ADDENDUM #2

WHITMAN & HAYES LIFT STATIONS PROJECT

ELECTRICAL BUILDING DETAILS & LAYOUT

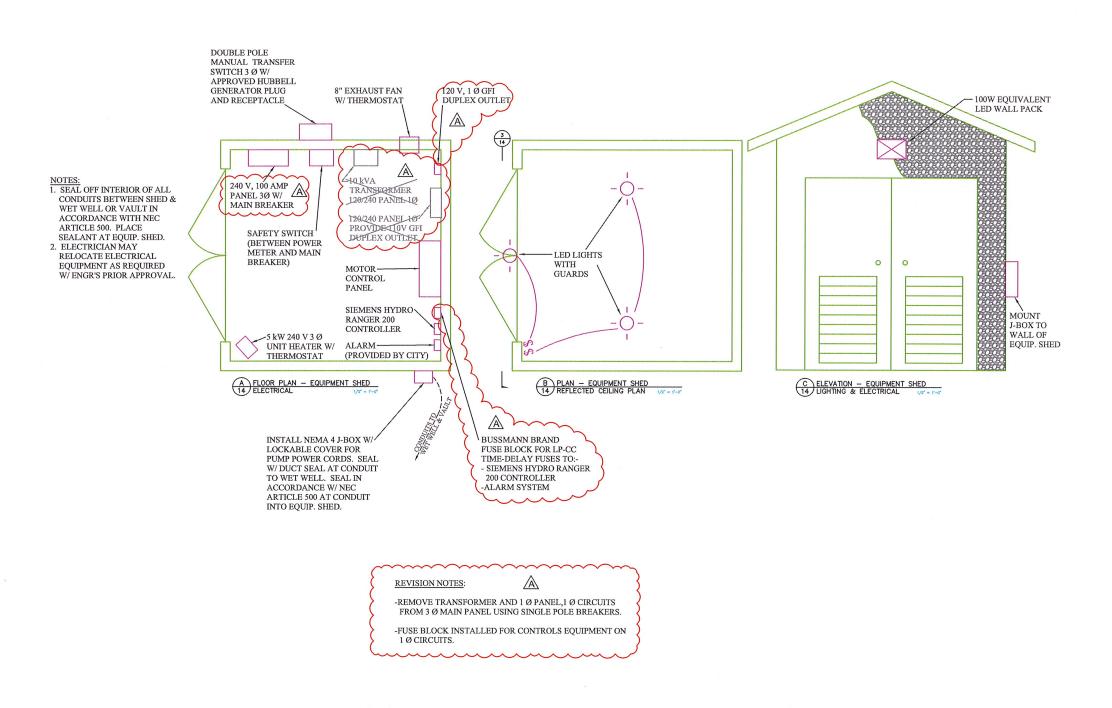
- 1. Revisions to Sheet 14 Electrical Building Details and Layout:
 - a) The 10 KVA Transformer and 120/240V 1-phase panel will be removed from the Project, 1-phase circuits will be supplied from the 3-Phase panel using single pole breakers.
 - b) Each 240V, 3-Phase main panel shall be rated for 100 amps.
 - c) Added Bussmann brand fuse block for LP-CC Time Delay Fuses to:
 - i. Siemens Hydro Ranger 200 Controller
 - ii. Alarm System

See attached revised Sheet 14 for modifications to the electrical equipment.

A ELECTRICAL MODIFICATIONS
